# Access Compliance Report

## Public Rights-of-Way

Intersection ID: 31349	Main Street: OAK_PASTURE_LN	Cross Street: SAGUARO_CT	Location: W
ADA ID: F45AFD3D5478	Ramp Type: PerpDiag	Initial Pass/Fail: Fail	Overall Compliance: No
Severity Score: 30			
Codes/Mitigation Info/Possible Solution		Field Measurements/Component Compliance

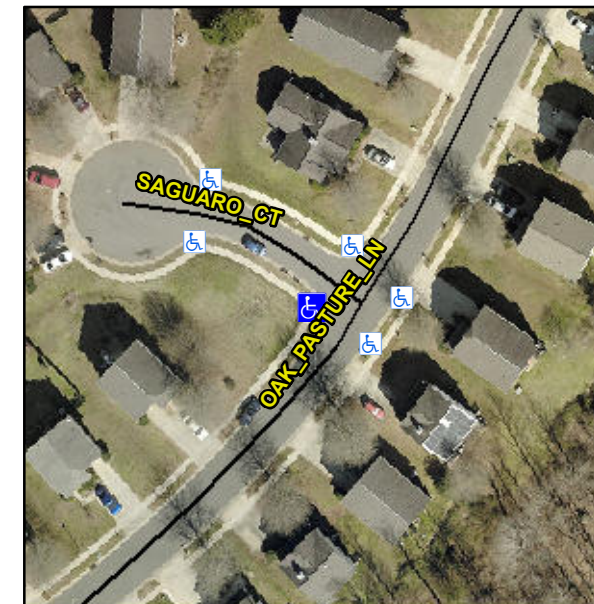
**R304.5.1, R304.2.2**

Compliance	Description	Data	Compliance	Description	Data
N/A	Ramp Length (in)	48.0	No	Ramp Slope (%)	9.8
No	Ramp Width (in)	32.0	Yes	Ramp XSlope (%)	1.6
N/A	Flare Type LT	N/A	N/A	Flare Type RT	N/A
N/A	Flare Slope LT (%)	N/A	N/A	Flare Slope RT (%)	N/A
N/A	Flare Traversable LT?	N/A	N/A	Flare Traversable RT?	N/A
N/A	Landing Length (in)	N/A	N/A	DWS Provided?	N/A
N/A	Landing Width (in)	N/A	N/A	DWS Contrast?	N/A
N/A	Landing Slope (%)	N/A	N/A	DWS Length (in)	N/A
N/A	Landing X Slope (%)	N/A	N/A	DWS Full Width?	N/A
N/A	Landing Curb? (Y/N)	N/A	N/A	DWS Offset (in)	N/A
N/A	Shared Landing?	N/A			
N/A	Gutter Ponding?	N/A	N/A	Gutter Slope (%)	N/A
N/A	Gutter Lip Ht (in)	N/A	N/A	Gutter X Slope (%)	N/A
N/A	Painted X Walk1?	No	N/A	Painted X Walk2?	No
	X Walk 1 Direction	To SE		X Walk 2 Direction	To NE
N/A	X Walk 1 Width (in)	N/A	N/A	X Walk 2 Width (in)	N/A
	X Walk 1 Slope (%)	0.7		X Walk 2 Slope (%)	0.2
	X Walk 1 X Slope (%)	1.0		X Walk 2 X Slope (%)	1.4

**Remove & Replace Curb Ramp With Two New Directional Ramps or Equivalent.**
